CORPORATE AUTOMOTIVE BULLETIN

Subject: Ford Drag Link -Torn Boots

Bulletin #: D19-09

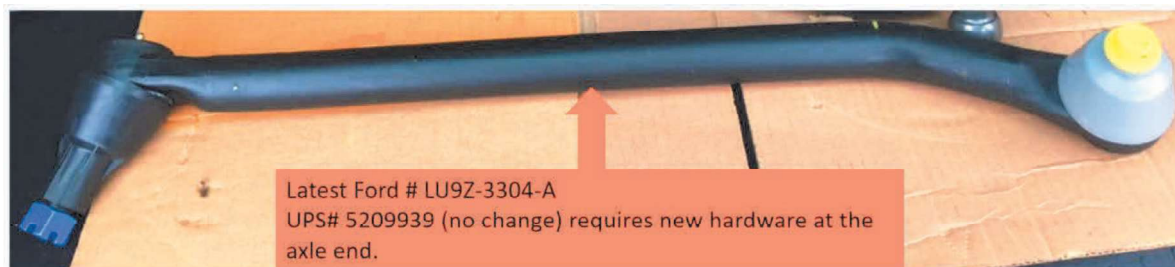
The purpose of this bulletin is to inform automotive personnel of changes to the Ford F59 drag link to reduce the boot tearing that has been experienced on some 2018 and early 2019 model year and older package cars. Production changes went into effect in June of 2021. If you experience a torn boot, order the following parts:

Ford part number history of the drag link is in the table below.

- UPS# 5209939 drag link assembly
- UPS # 5211910 nut
- UPS # 5211913 castellated retainer
- UPS # 5211916 cotter pin
